CORRECTIVE ACTION DECISION/
RECORD OF DECISION
FOR
ROCKY FLATS PLANT (USDOE)
PERIPHERAL OPERABLE UNIT
AND
CENTRAL OPERABLE UNIT

JEFFERSON AND BOULDER COUNTIES, COLORADO

DECLARATION

Boundaries of the Peripheral and Central Operable Units

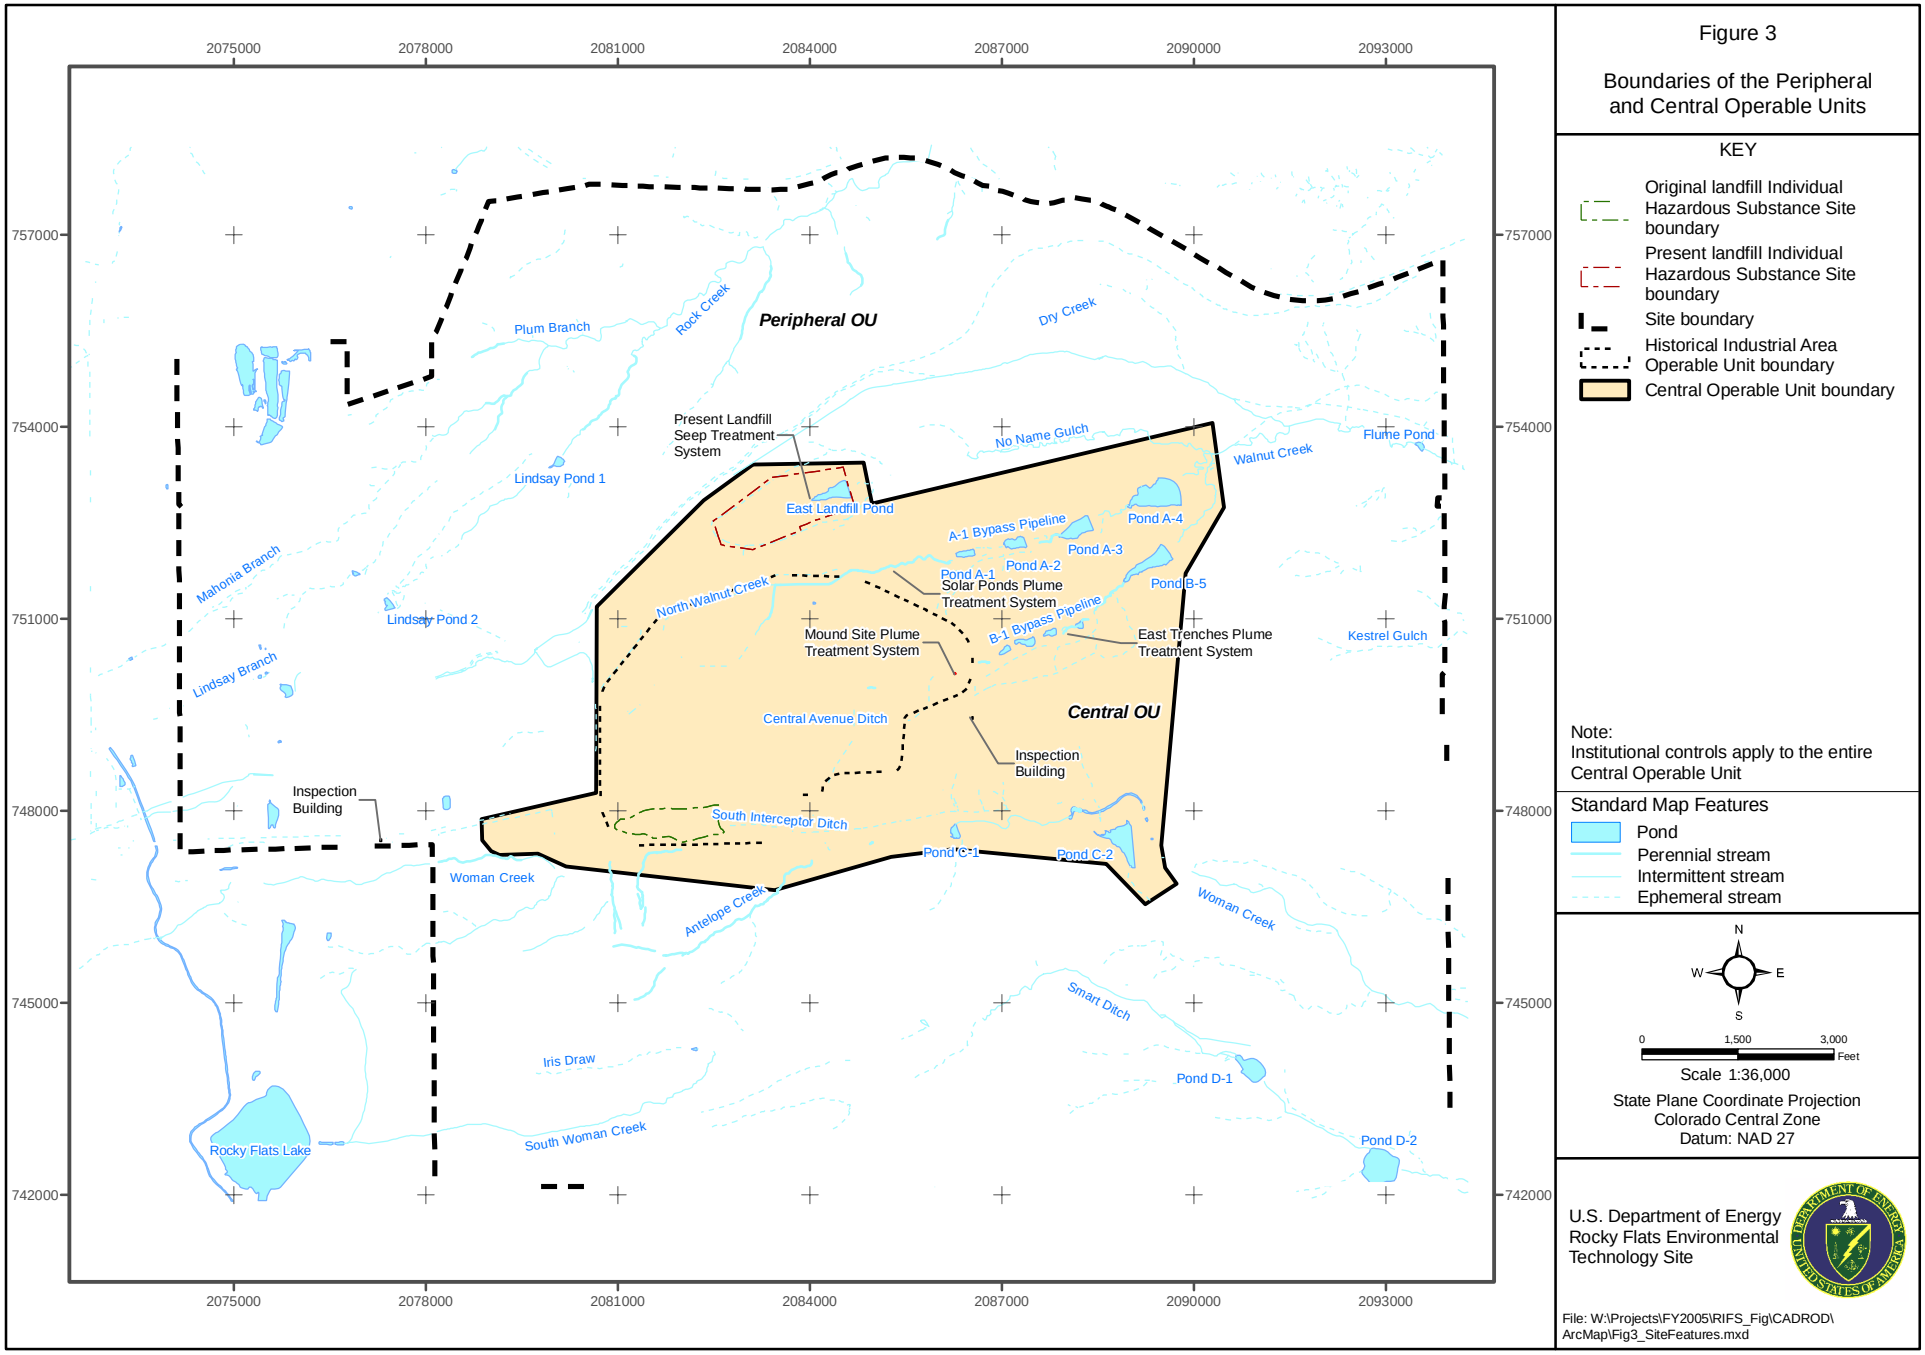
35. 2.1.8 We are very concerned the document does not address if or how institutional controls would apply to boundary wells. Revise the document to state ICs will apply to the boundary wells. Revise Figure 3 to include a delineation of the groundwater boundary wells. The Plan should also include a statement that the land/area the wells are located in will be retained by DOE.	Boundary wells are not required by the CAD/ROD. Although boundary wells are not located within the DOE-retained lands, the Refuge Act provides for DOE's access to them, and DOE will be required to maintain and protect these wells to ensure that they continue to function as designed. Requirements for monitoring at the boundary wells will be included in the RFLMA.

43. 2.2.3 Revise Figure 3 to include a delineation of the surface water monitoring stations. The Plan should also include a statement that the land/area the surface water stations are located in will be	DOE is developing a map or maps to address your comment. DOE will be required to maintain and protect these locations to ensure that they continue to function as designed. Per the Refuge Act,

77. 3.1.4 Revise the boundary map, Figure 3, to include stamped areas retained by DOE for the Points-of-Compliance.	DOE is developing a map or maps to address your comment.

78. 3.1.5 Revise the boundary map, Figure 3, to include stamped areas retained by DOE for the groundwater wells at the site boundary.	DOE is developing a map or maps to address your comment.

79. 3.1.6 Revised the boundary map, Figure 3, to include stamped areas retained by DOE for surface water stations located outside of the DOE retained lands.	DOE is developing a map or maps to address your comment.

81. 3.2.1 The plan provides a map, Figure 3, delineating the Operable Unit (OU) boundaries. The RFCA Parties have decided to reconfigure the OU boundaries to consolidate all areas of the site that may require additional remedial actions into a final reconfigured Central OU. *The boundary of the new Central OU, also considers practicalities of future land management.* Broomfield understands the need Legacy Management (LM) has to establish a footprint that is as small a possible to reduce management cost and liability. We believe remedy evaluation and remedy protection have far greater justification to determine a boundary than the land management practicalities that were provided as justification for the proposed boundary.	The RI found that conditions in the Peripheral OU were suitable for unrestricted use and unlimited exposure. No use restrictions of any kind are necessary for the Peripheral OU. The boundary of the Central OU was determined based on data contained within the Proposed Plan as well as the RI/FS. The "practicalities of future land management" address minor adjustments to the boundary in consideration of sensitive habitats and surface topography. Remedy selection and protection is the driver behind the location of the boundary.

88. 3.2.8 Revise the map, Figure 3, to move the boundary north of the Present landfill at least 300 feet from landfill boundary. It may be practical to follow the road north of the landfill, but the area northeast of the landfill should be pushed further north to protect the cap based on the proximity to the road and the cap.	The boundary of the Central OU was determined based on data contained within the Proposed Plan as well as the RI/FS. The OU boundary established in the Proposed Plan fully encompasses the Present Landfill and is protective.

90. 3.2.10 It is germane to identify the above mentioned POCs, surface water monitoring stations, and boundary wells on the map, Figure 3. Language for implementation of ICs and access controls shall be included in the Proposed Plan. We ask to participate with the development of the controls prior to the release of the final CAD/ROD. If sufficient controls are in place, we support Alternative 2. If clear controls are not defined, implemented, or enforced, we would therefore support Alternative 3.	DOE is developing a map or maps to address your comment. Early draft efforts have shown that including all the information listed in your comment on a single map makes it so cluttered that it is unreadable. The suggested revisions are inappropriate for the Proposed Plan, which develops broad alternatives for remedial action. Approval of the CAD/ROD will select the alternative and establish the requirements to implement that alternative. More detailed information describing how DOE will meet the requirements of the CAD/ROD, including the topics in your comment, will be written in the RFLMA. The RFLMA will be made available for public comment, and once approved by the EPA and CDPHE, will replace the current RFCA as the enforceable agreement to ensure compliance with CERCLA, RCRA, and the CHWA.

35. 2.1.8 We are very concerned the document does not address if or how institutional controls would apply to boundary wells. Revise the document to state ICs will apply to the boundary wells. Revise Figure 3 to include a delineation of the groundwater boundary wells. The Plan should also include a statement that the land/area the wells are located in will be retained by DOE.	Boundary wells are not required by the CAD/ROD. Although boundary wells are not located within the DOE-retained lands, the Refuge Act provides for DOE's access to them, and DOE will be required to maintain and protect these wells to ensure that they continue to function as designed. Requirements for monitoring at the boundary wells will be included in the RFLMA.

43. 2.2.3 Revise Figure 3 to include a delineation of the surface water monitoring stations. The Plan should also include a statement that the land/area the surface water stations are located in will be retained by DOE.	DOE is developing a map or maps to address your comment. DOE will be required to maintain and protect these locations to ensure that they continue to function as designed. Per the Refuge Act, DOE may access any areas, whether in the Central OU or Peripheral OU, required for monitoring or remedy purposes.

77. 3.1.4 Revise the boundary map, Figure 3, to include stamped areas retained by DOE for the Points-of-Compliance.	DOE is developing a map or maps to address your comment.

78. 3.1.5 Revise the boundary map, Figure 3, to include stamped areas retained by DOE for the groundwater wells at the site boundary.	DOE is developing a map or maps to address your comment.

79. 3.1.6 Revised the boundary map, Figure 3, to include stamped areas retained by DOE for surface water stations located outside of the DOE retained lands.	DOE is developing a map or maps to address your comment.

81. 3.2.1 The plan provides a map, Figure 3, delineating the Operable Unit (OU) boundaries. The RFCA Parties have decided to reconfigure the OU boundaries to consolidate all areas of the site that may require additional remedial actions into a final reconfigured Central OU. *The boundary of the new Central OU, also considers practicalities of future land management.* Broomfield understands the need Legacy Management (LM) has to establish a footprint that is as small a possible to reduce management cost and liability. We believe remedy evaluation and remedy protection have far greater justification to determine a boundary than the land management practicalities that were provided as justification for the proposed boundary.	The RI found that conditions in the Peripheral OU were suitable for unrestricted use and unlimited exposure. No use restrictions of any kind are necessary for the Peripheral OU. The boundary of the Central OU was determined based on data contained within the Proposed Plan as well as the RI/FS. The "practicalities of future land management" address minor adjustments to the boundary in consideration of sensitive habitats and surface topography. Remedy selection and protection is the driver behind the location of the boundary.

disagree with DOE that the two crucial surface water stations should be located outside of the DOE retained lands. There is no justification to exclude these water stations from DOE retained lands. Revise Figure 3 to expand the DOE retained lands to include GS-05 and GS-59. These stations are not located in steep areas, nor are they in riparian areas. The other alternative is to manage all the surface water stations consistently at the site and apply institutional and physical controls to these two stations associated with the Original Landfill. They would have to have additional layers of protection just as the POCs and the boundary wells at Indiana Street. All monitoring stations and wells should be maintained, operated, and funded by DOE.

88. 3.2.8 Revise the map, Figure 3, to move the boundary north of the Present landfill at least 300 feet from landfill boundary. It may be practical to follow the road north of the landfill, but the area northeast of the landfill should be pushed further north to protect the cap based on the proximity to the road and the cap.	The boundary of the Central OU was determined based on data contained within the Proposed Plan as well as the RI/FS. The OU boundary established in the Proposed Plan fully encompasses the Present Landfill and is protective.

90. 3.2.10 It is germane to identify the above mentioned POCs, surface water monitoring stations, and boundary wells on the map, Figure 3. Language for implementation of ICs and access controls shall be included in the Proposed Plan. We ask to participate with the development of the controls prior to the release of the final CAD/ROD. If sufficient controls are in place, we support Alternative 2. If clear controls are not defined, implemented, or enforced, we would therefore support Alternative 3.	DOE is developing a map or maps to address your comment. Early draft efforts have shown that including all the information listed in your comment on a single map makes it so cluttered that it is unreadable. The suggested revisions are inappropriate for the Proposed Plan, which develops broad alternatives for remedial action. Approval of the CAD/ROD will select the alternative and establish the requirements to implement that alternative. More detailed information describing how DOE will meet the requirements of the CAD/ROD, including the topics in your comment, will be written in the RFLMA. The RFLMA will be made available for public comment, and once approved by the EPA and CDPHE, will replace the current RFCA as the enforceable agreement to ensure compliance with CERCLA, RCRA, and the CHWA.
